**PLANNING COMMISSION STAFF REPORT  
100 S GARFIELD STREET SUBDIVISION – PRELIMINARY PLAT  
SUB322-0001/ADJC23-0002**

**FILE NO:** SUB322-0001 / ADJC23-0002

**REQUEST:** Subdivide a 1.93acre property into 8 residential lots

**Exhibit C:  
Preliminary Plat**

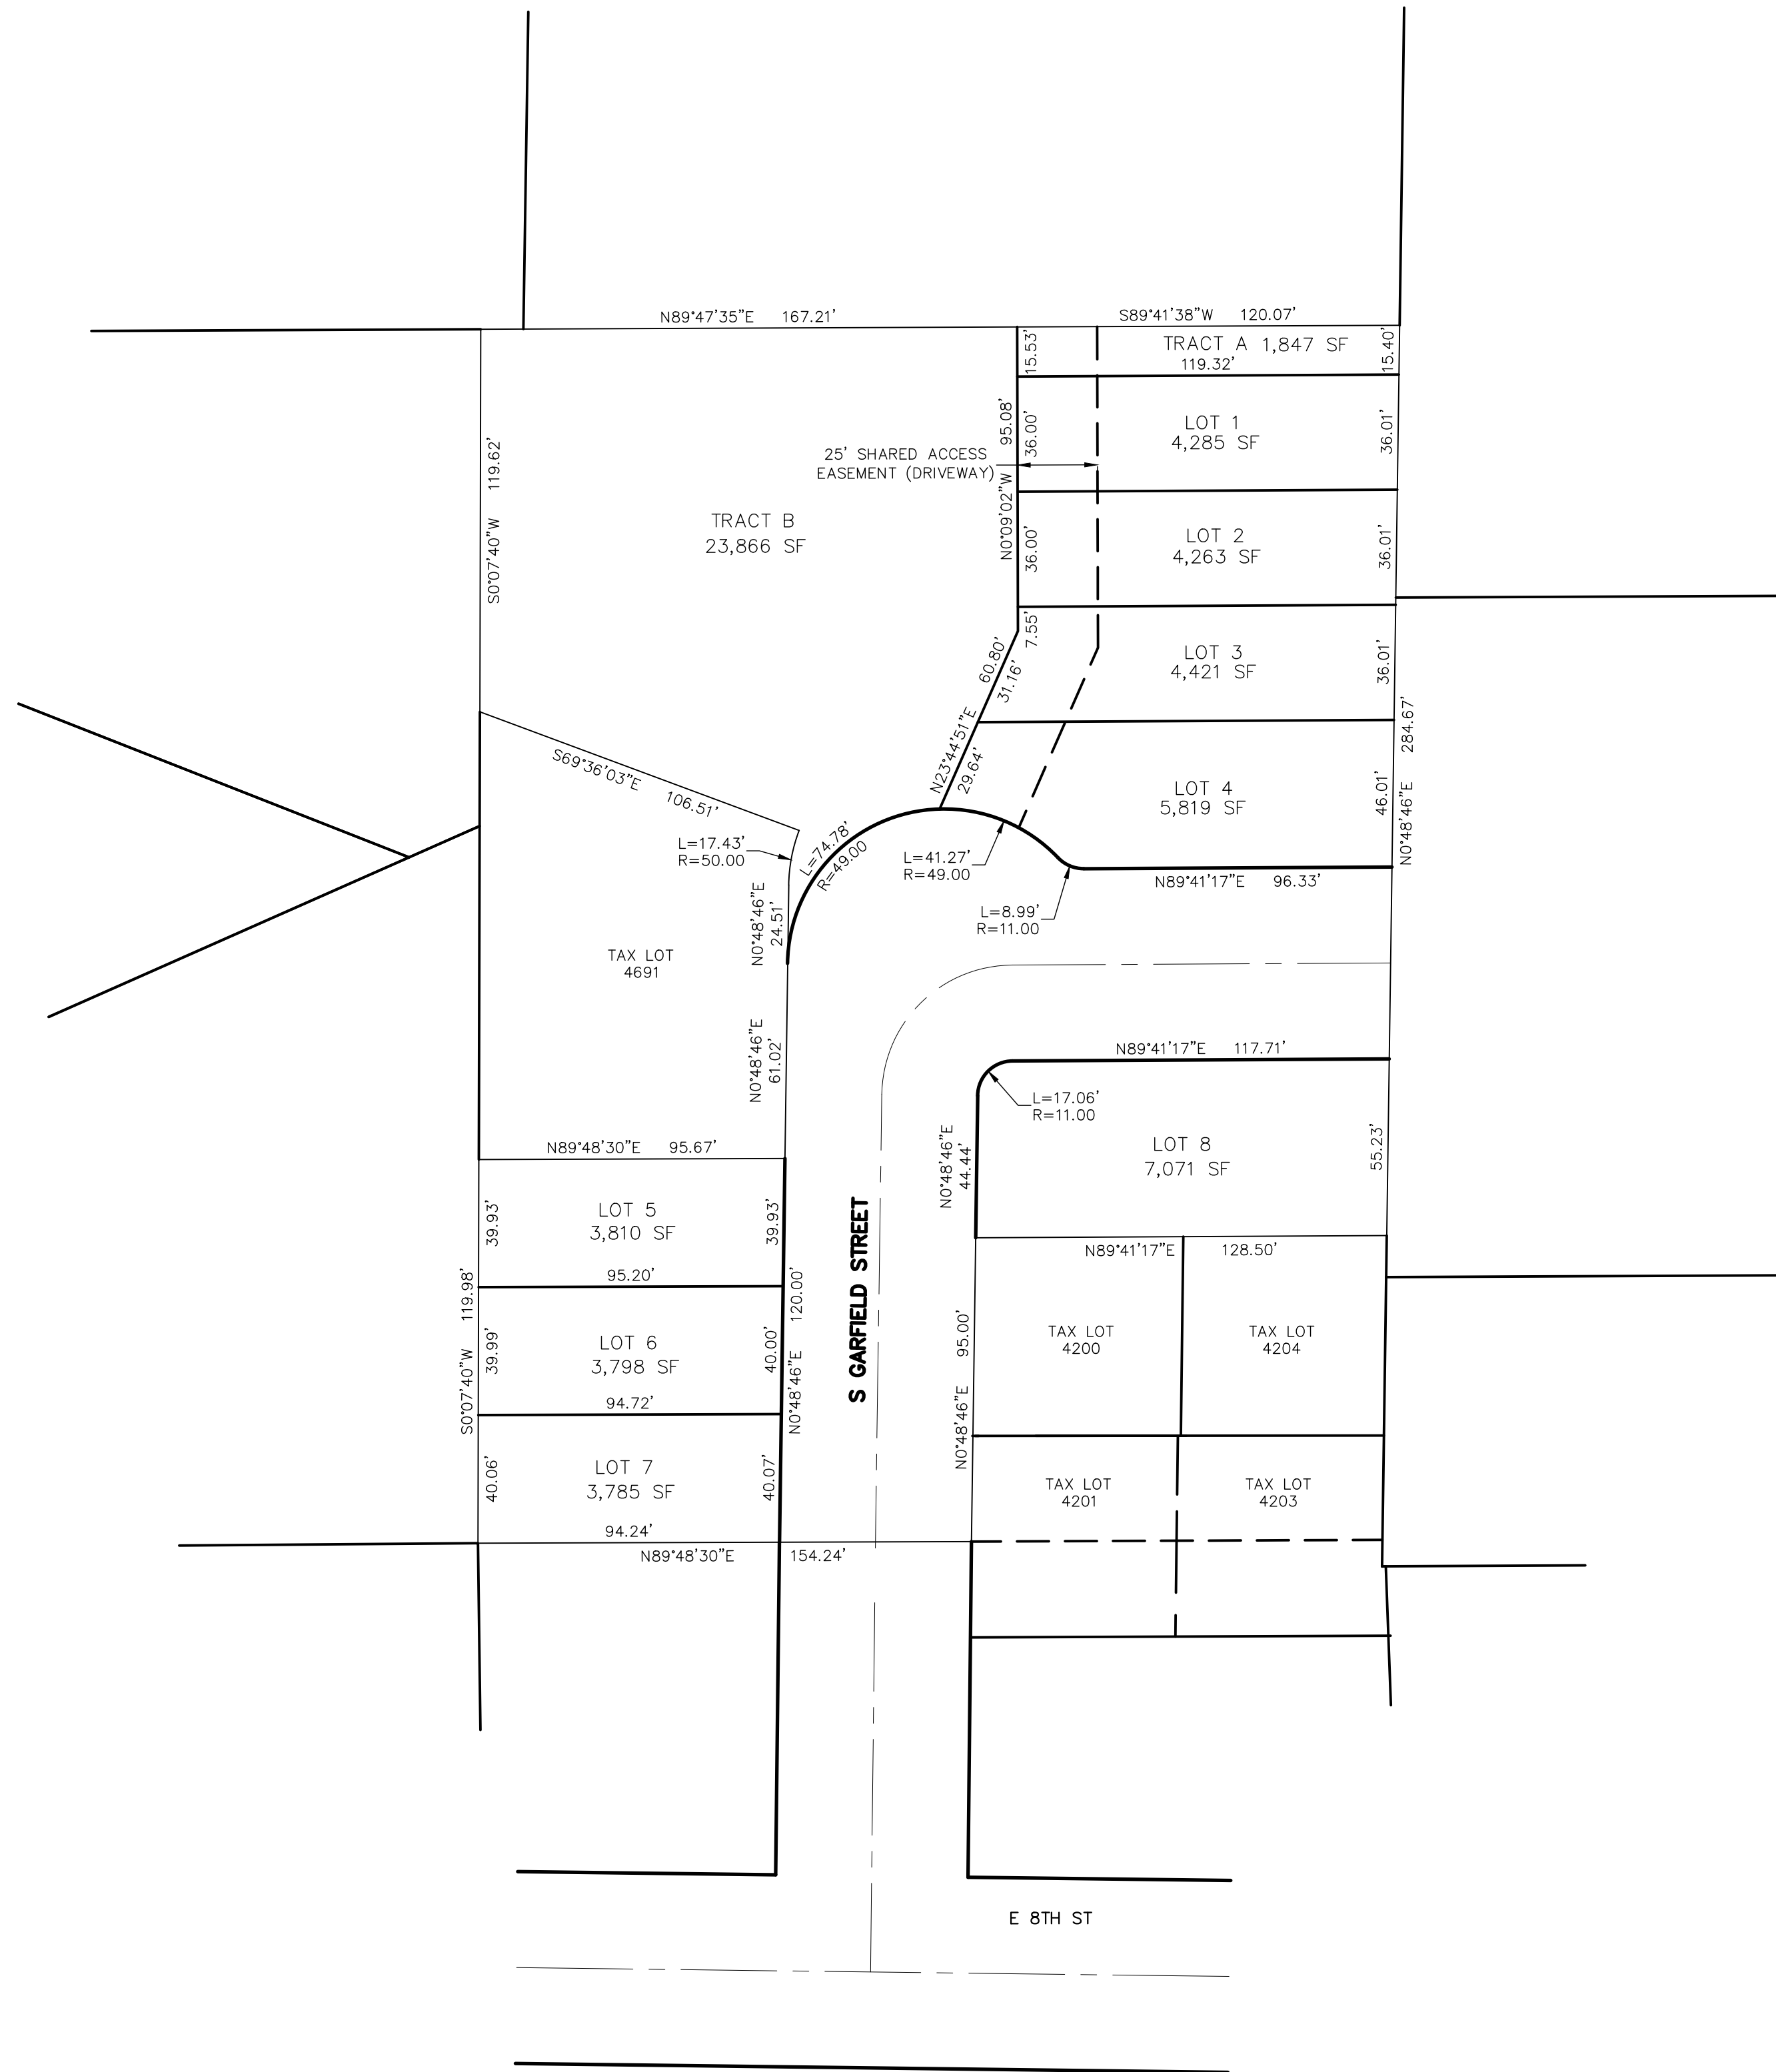
**Finding:** The preliminary plat shows that the proposed stormwater facility, Tract A, will encroach into the stream corridor overlay area and disturb two separate areas totaling approximately 665 square feet. The stormwater facility will discharge into Tract B, that is located within the stream corridor area. The applicant's narrative does address that the area disturbed by the installation of the stormwater facility will be replanted per the included mitigation plan, sheet 6. The proposed stormwater facility is not listed within an approved City of Newberg master infrastructure plan. Therefore, does not qualify as a Type II activity per NMC 15.342.070(D). The installation of a stormwater facility, not within an approved master plan, is most closely related to the activity described in subsection B and therefore, will processed as a Type I procedure. However, due to the requirements of NMC 15.235 that requires proposed subdivisions within a stream corridor to be decided by the Planning Commission, this criterion will also be reviewed by the Planning Commission and not the approved by the director as this section directs.

**Finding:** Through the platting of this this subdivision the duplex will be on a single corner lot, Lot 8. Therefore, it will have a front yard setback along the new street that will terminate at the east property line, and a street side yard setback along the new extension of S Garfield Street. This new street configuration will provide the duplex a 15-foot front yard setback to the building from the new terminated street. The extension of S Garfield Street however does not

provide the required 15-foot for the street side yard. This was reviewed under the associated code adjustment (ADJC23-0002) requesting a reduction to the street side yard by 19%. Staff found this reduction meets all adjustment criteria and the street side yard will be reduced to 12.1 feet.

**Finding:** The location of the new street does not provide the required 20-foot garage setback from the street. This was reviewed under the associated code adjustment (ADJC23-0002) requesting a reduction to the garage front yard setback by 25%. Staff determined this reduction meets all adjustment criteria and the garage will have a 15-foot setback.
